From: Ellison, Mark
Sent: 08 April 2024 11:53
To: Harrison, Liz
Subject: Planning App Consultation Request Internal DC/23/95627 for condition 16 (Proposed Local Areas of Play) for Boorley Gardens Phase 2

Landscape comments for DC/23/95627 for condition 16 (Proposed Local Areas of Play) for Boorley Gardens Phase 2

Description: Discharge of conditions application following reserved matters consent RM/18/84466 (pursuant to outline permission O/15/75953, as amended by X/19/84943) for condition 16 (Proposed Local Areas of Play) for Boorley Gardens Phase 2.

MILL22017 11K Sheet 3

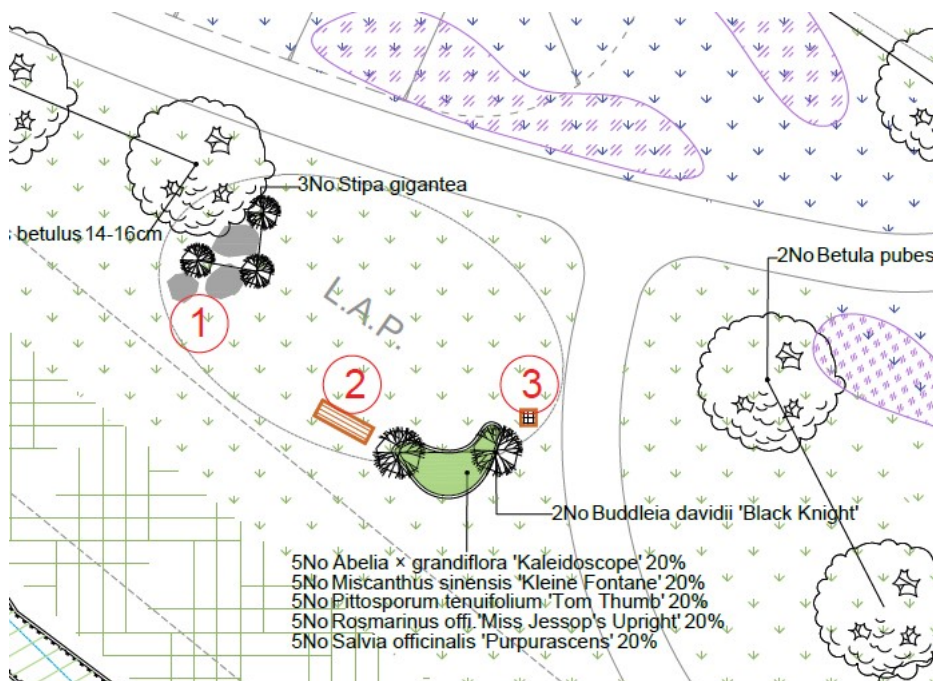
1. The immediate area of the LAP needs to have a specific ryegrass based hard wearing seed mix, or turf specified. The wildflower mix won't be hard wearing enough.

2. The rock area should have more rocks in it and be more interesting. Rocks from play companies tend to be very expensive. I have used rocks direct from a quarry in Somerset in the past in a play area. You'd need to write a short spec, to make sure that there are no sharp edges etc, but otherwise the stone should be fine. There is a risk of some flaking, but my view is that this all feeds into the richness of the play experience. The contact is; Harvey Stone, Ham Hill Masonry Works, Ham Hill, Stoke - Sub - Hamdon, Somerset, TA14 6RW
Phone: +44 (0)1935 824950
Fax: +44 (0)1935 825944

3. The bench should be located on a paved surface, large enough to prevent wear by feet of seated persons and remove the need for strimming around the bench legs.

4. The waste bin is positioned at a curious angle: it should align centrally to a radial line drawn from the centre of the ellipse shape.
5. The planting design should be carefully considered, and each species located. It's not acceptable to delegate the design of this to the contractor. There should be balance in the numbers of each species in relation to their role in the composition and ultimate spread: having equal number of each species is too simplistic an approach. Taller plants should be set properly amongst larger numbers of smaller plants (unless the smaller plants have a

widespread). Please swap the location of the Buddleia nearest the bench with the Stipa furthest from it. The two Buddleia together set up an awkward symmetry and anyway it not a great idea to locate such a bee magnet of a plant so close to a bench. Please add some **clumping** bamboos to the rock area to increase the display and play value. In the past I've used Fargesia robusta 'Campbell', Fargesia rufa and Fargesia nitida 'Volcano' before. The bed on the east side should be enlarged by at least 50%.

6. Display of spring bub planting required.

MILL22017 11K Sheet 7 Some comments repeated from above in whole, in part or part modified

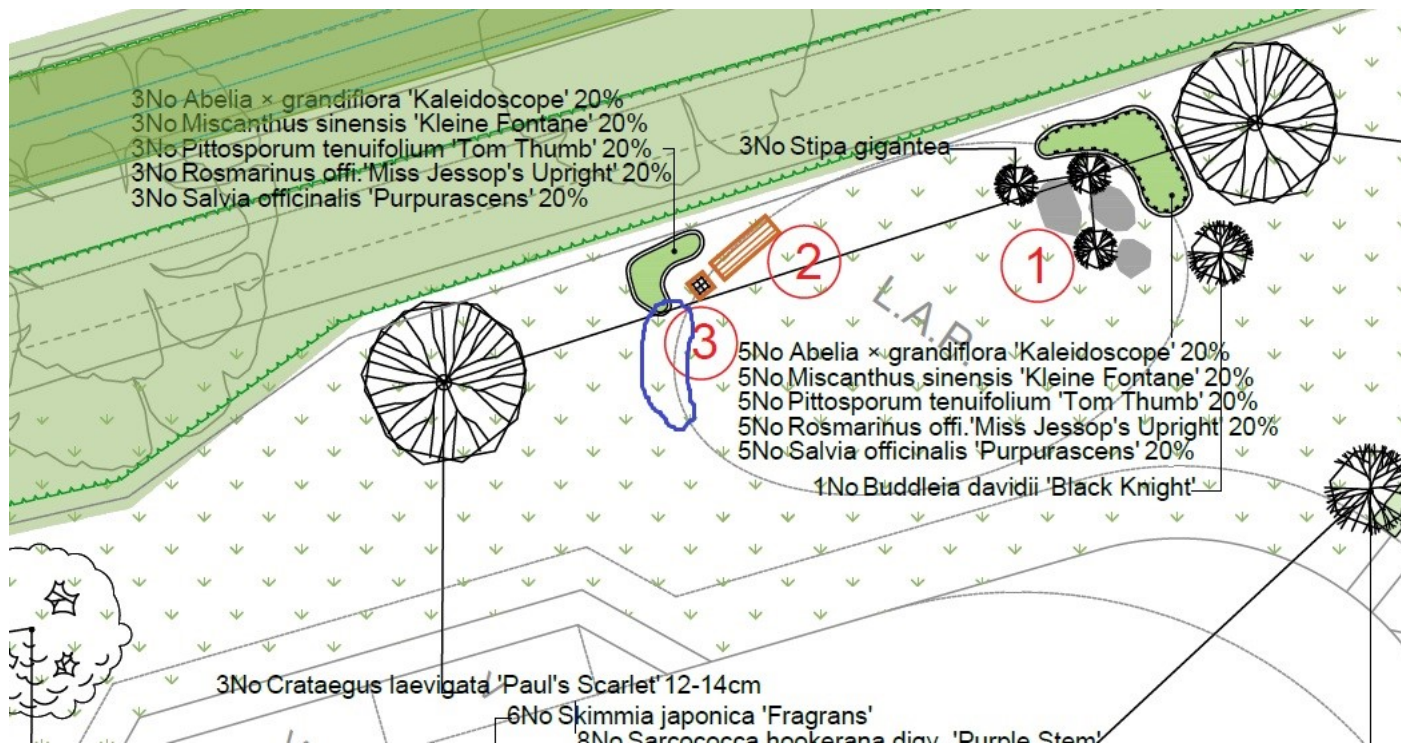
1. The immediate area of the LAP needs to have a specific ryegrass based hard wearing seed mix, or turf specified. The wildflower mix won't be hard wearing enough.

2. The rock area should have more rocks in it and be more interesting. Rocks from play companies tend to be very expensive. I have used rocks direct from a quarry in Somerset in the past in a play area. You'd need to write a short spec, to make sure that there are no sharp edges etc, but otherwise the stone should be fine. There is a risk of some flaking, but my view is that this all feeds into the richness of the play experience. The contact is; Harvey Stone, Ham Hill Masonry Works, Ham Hill, Stoke - Sub - Hamdon, Somerset, TA14 6RW

3. The bench should be located on a paved surface, large enough to prevent grass wear by feet of seated persons and remove the need for strimming around the bench legs .

4. Please position the bin a little further form the bench or perhaps on the east side of the space. It also doesn't work having such a formal relationship in the positioning of the two items in what is a relatively informal setting.

5. To create variety there should be no more than 30% of the shrub/ornamental grass species common to each of the three LAPs. The shape and size of the bed to the west side of the play area isn't in scale with the space: please amend as shown with the blue line above. The planting design should be carefully considered, and each species located. It's not acceptable to delegate the design of this to the contractor. There should be balance in the numbers of each species in relation to their role in the composition and ultimate spread: having equal number of each species is too simplistic an approach. Taller plants should be set properly amongst larger numbers of smaller plants (unless the smaller plants have a widespread). Please add some **clumping** bamboos to the rock area to increase the display and play value. In the past I've used Fargesia robusta 'Campbell', Fargesia rufa and Fargesia nitida 'Volcano' before.

6. Display of spring bub planting required.

MILL22017 11K Sheet 9 Some comments repeated from above in whole, in part or part modified

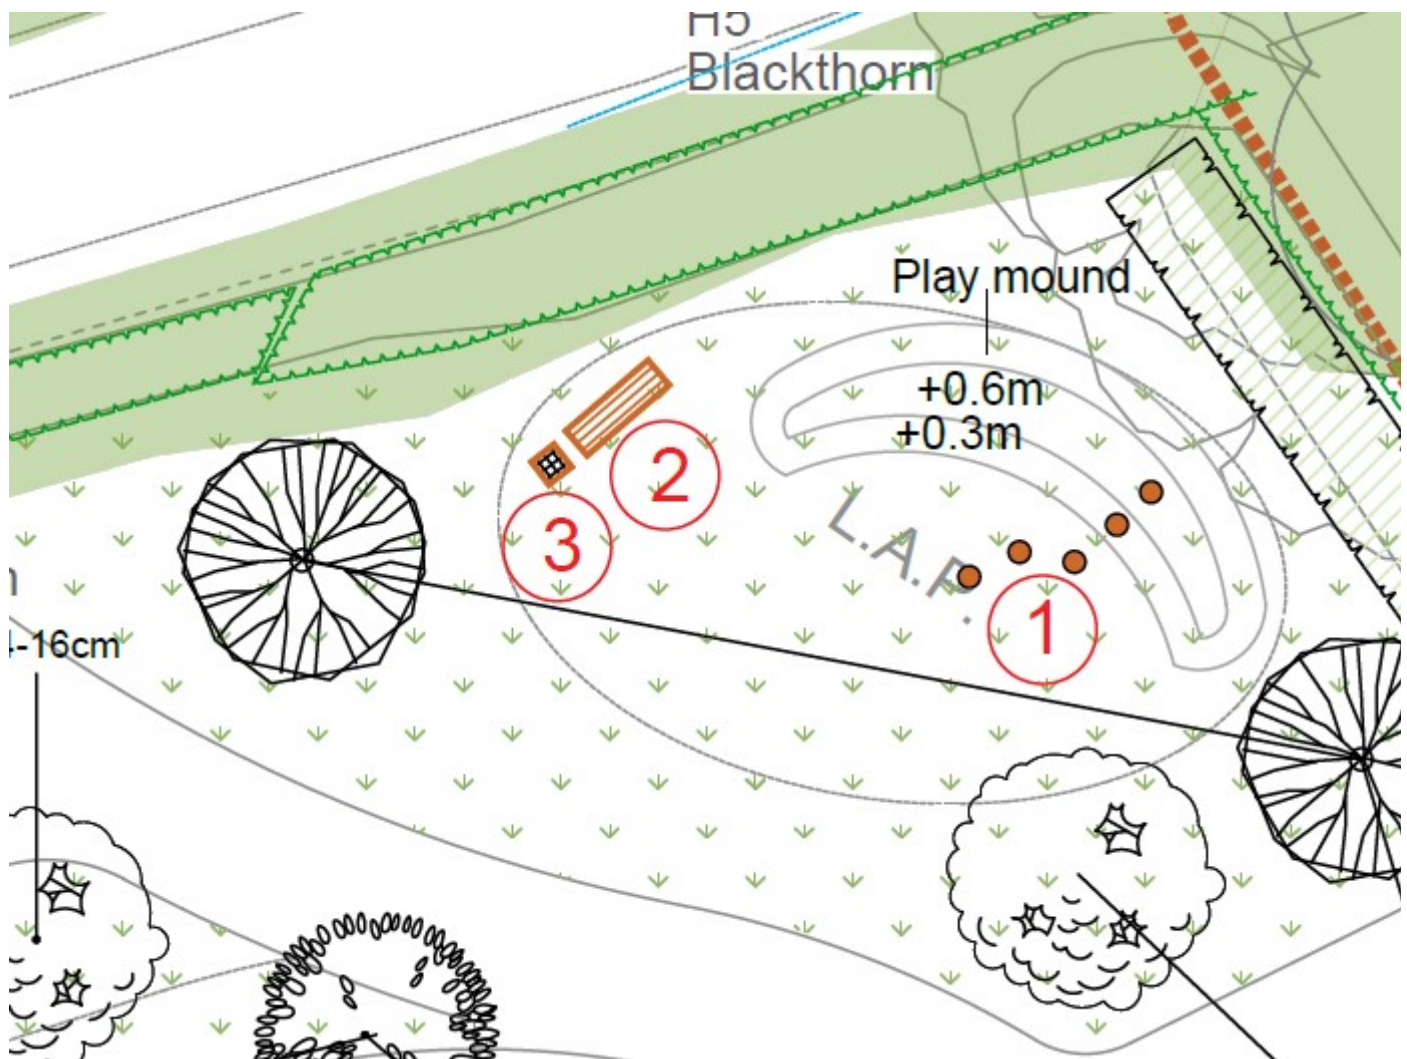
1. The immediate area of the LAP needs to have a specific ryegrass based hard wearing seed mix, or turf specified. The wildflower mix won't be hard wearing enough.

2. The timber post and mound design is a good idea to contrast with the other two LAPs. My only comment on this aspect is that there should be a more posts, they should have varied interval distances and they should be made from Robinia timber in different heights and with timber diameters.

3. The bench should be located on a paved surface, large enough to prevent wear by feet of seated persons and remove the need for strimming around the bench legs.

4. Please position the bin a little further from the bench or perhaps on the east side of the space. It also doesn't work having such a formal relationship in the positioning of the two items in what is a relatively informal setting.

5. In addition to the native planting to the east of the space there should also be an area of ornamental planting, as included adjacent to the other LAPs. The planting design should be carefully considered, and each species located. It's not acceptable to delegate the design of this to the contractor. There should be balance in the numbers of each species in relation to their role in the composition and ultimate spread: having equal number of each species is too simplistic an approach. Taller plants should be set properly amongst larger numbers of smaller plants (unless the smaller plants have a widespread). Please swap the location of the Buddleia nearest the bench with the Stipa furthest from it. The two Buddleia together set up an awkward symmetry and anyway it not a great idea to locate such a bee magnet of a plant so close to a bench. Please add some **clumping** bamboos to the rock area to increase the display and play value. In the past I've used *Fargesia robusta* 'Campbell', *Fargesia rufa* and *Fargesia nitida* 'Volcano' before.

6. Display of spring bub planting required.
